LiDAR Quality Assessment Report

AL_BlountCounty_2010-2011

The Atlantic Group

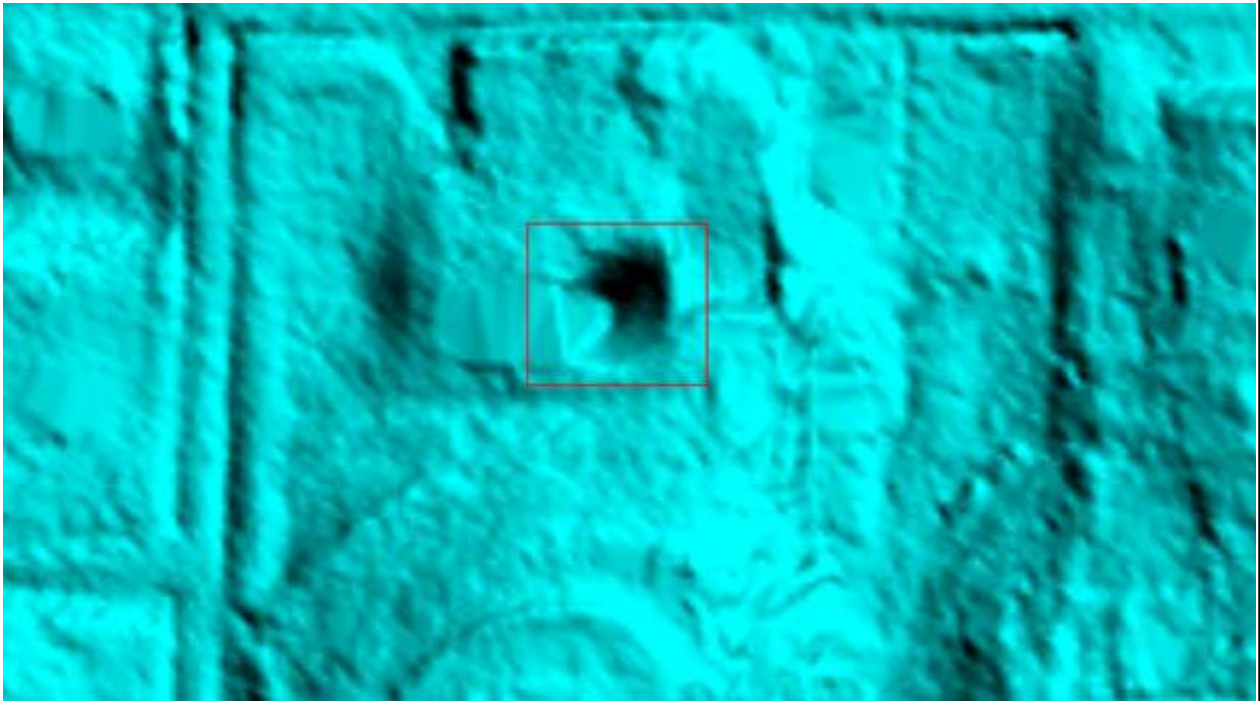
Tile 547500_3768000 includes no DEM data

corrected by vendor
